Subject: Class II permissive change Request

FCC ID: U2BRL039AT9S

Granted on: 08/03/2016

1.

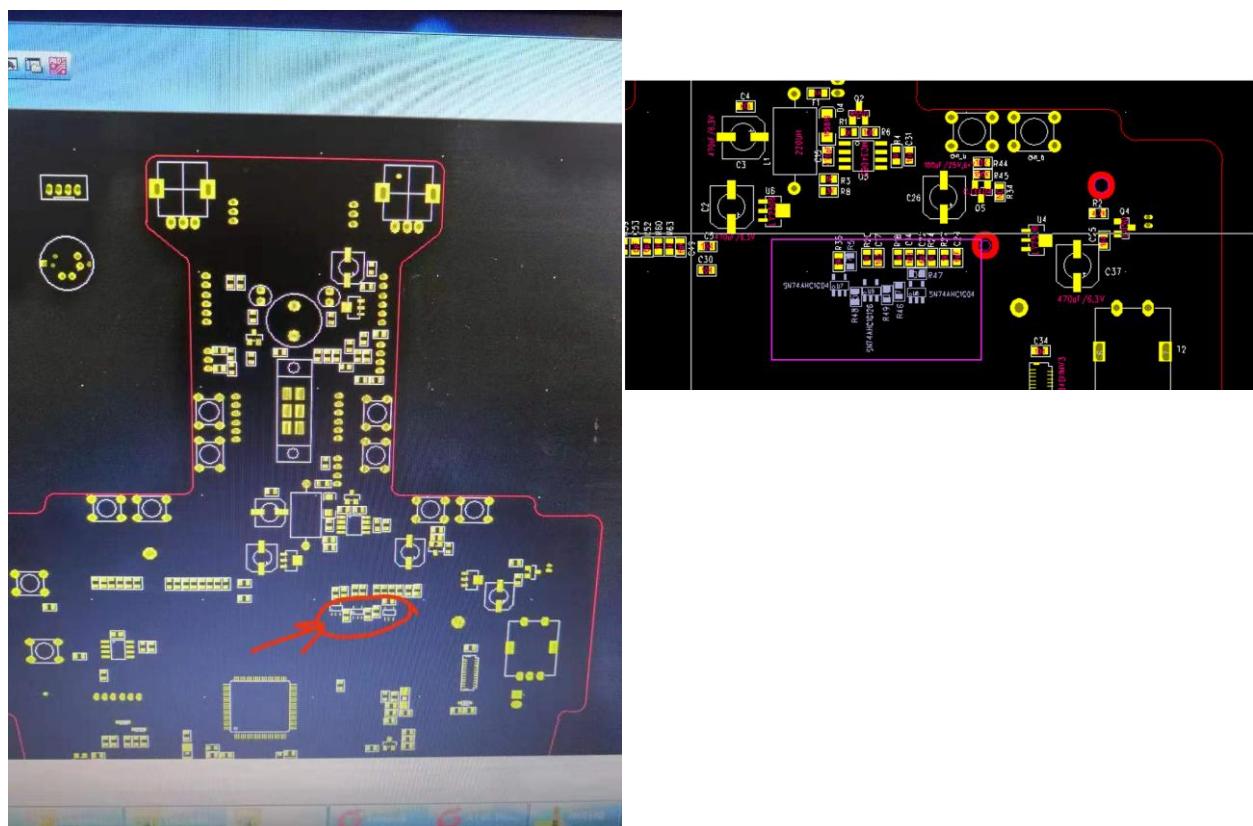
1. Model Change from AT9S to AT9S Pro as follow pictures 1.
2. Hardware change: The hardware version number is changed from REV: 2.0 to REV: 3.0 as follow files.
3. to not affect the normal use of the machine performance, the layout of the plate as far as possible to avoid the position of the antenna.
4. in order to meet the needs of customers, we make new software, so that AT9S Pro has more performance, but it will not affect the RF performance and the electrical performance of the machine.
5. PCBA (Printed Circuit Board Assembly) adds eight components as follow pictures 2 and 3.
